DEVELOPMENT REVIEW BOARD
SUPPLEMENTAL SUBMITTAL

PROJECT NO. PR-2021-006070

Re: Westpointe40 North Site Plan DRB Comment Responses (PR-2021-006070)

This memo outlines the responses and changes made to the site plan for the proposed 150K spec industrial building at Westpointe40 based on the comments received and reviewed at the December 1, 2021 DRB meeting. The comments are numbered and followed by the response in italics.

TITAN 150K SPEC BUILDING ALBUQUERQUE, NM	DRAWN BY pm
	SITE PLAN FOR BUILDING PERMIT	DATE 12-6-21
	5571 MIDWAY PARK PL NE ALBUQUERQUE, NEW MEXICO 87109 (505) 858-3100 www.tierrawestllc.com	DRAWING 2020088-150K.DWG
		SHEET # SP-1
RONALD R. BOHANNAN P.E. #7868		JOB # 2020088

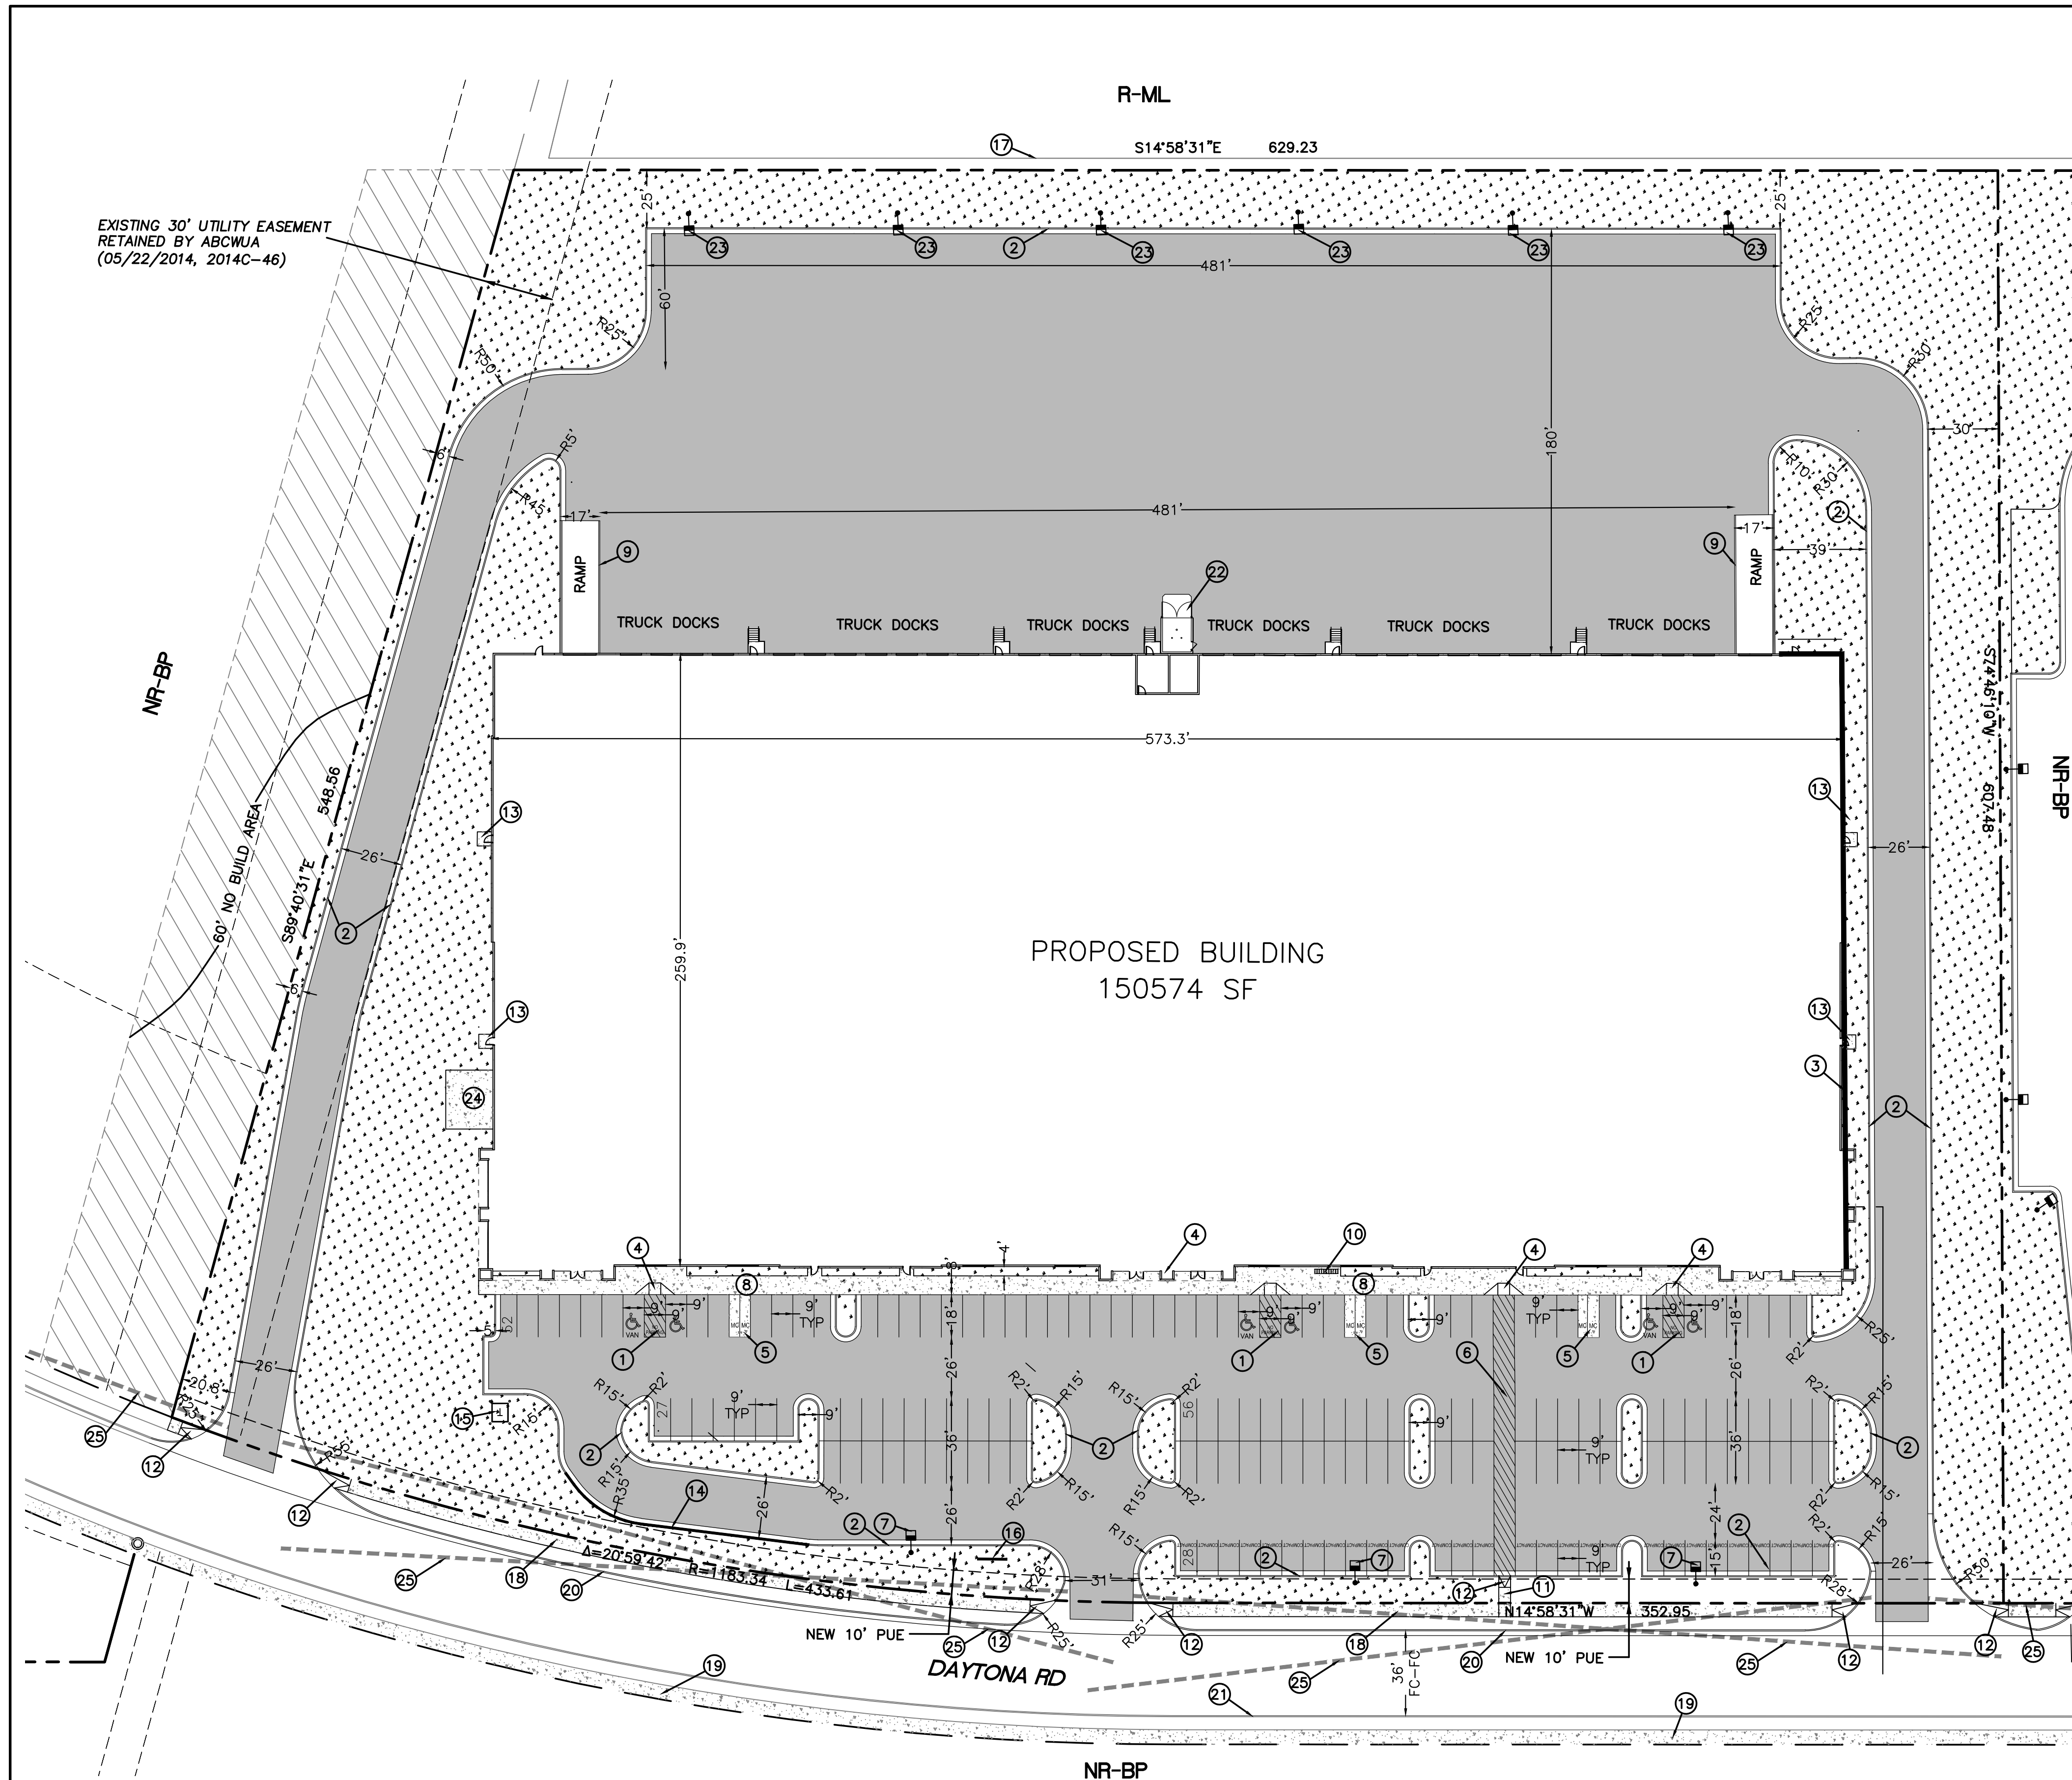
1. The Site Plan must comply with all applicable provisions of the IDO, the DPM, and other adopted City regulations.
 - *Understood.*
2. IDO Zone district is NR-BP.

6. Additional detail needed for meeting equipment screening and loading, service refuse areas. IDO section 5-6-G.
 - *The loading, service, and refuse areas are located at the rear of the building where they are not visible from the adjacent street, as required by this section. The property to the east is not considered low-density residential, so it is not strictly required by the IDO to provide screening beyond the landscape edge buffer requirements. There is an existing 8-foot-tall perimeter wall for the multi-family development that will be further enhanced by the 25-foot landscape buffer, so there will still be significant screening of the service and loading area from the east. If considered an outdoor storage area for the purposes of Section 5-6(G)(4) due to trailer parking, the existing 8-foot-tall wall satisfies the screening requirement.*

7. Additional detail needed for meeting outdoor lighting. IDO section 5-8.
 - *Keynote 23 identifies the site lighting with a maximum height of 16 feet tall. This is the maximum height allowed within 100 feet of a residential zone district per Table 5-8-1.*

- *Per Section 5-11(E)(3), a 500 square foot patio space is provided on the north side of the building (reference Keynote 24)*
9. Does project submittal include a signage plan or is owner applicant referencing the NR-C zone district for standards?

2. Provide a 6-foot ADA pathway from the building to the right-of-way.
 - *The pedestrian connection has been updated with the required width (Keynote 11).*

- *Please see the response to Code Enforcement comment #8.*
5. The building setbacks are depicted on the Site Plan as 5-feet for the front, and 0-feet for the sides and rear. The setback requirements in the NR-BP zone district are 20-feet for the front, and 10-feet for the sides and rear. The setbacks for the buildings based on the NR-BP standards appear to be met. Confirm that the setbacks are being met and note the correct required setback standards and the setbacks for the proposed buildings on the Site Plans.

- *Understood. The project has been designed to comply with the NR-BP zone district regulations.*
3. Dimensional standards per IDO section 5-1. Clarify different setback notes on plat.

- *The setbacks on the site plan have been updated to correctly reflect the NR-BP zone district standards, and the plan complies with these setbacks.*

- *No specific signage plan is proposed except for showing a potential location for a monument sign (Keynote 16). Further details will be required through the separate sign permit process and will comply with the NR-C standards as allowed by the IDO.*

- *The setbacks have been updated on the site plan.*
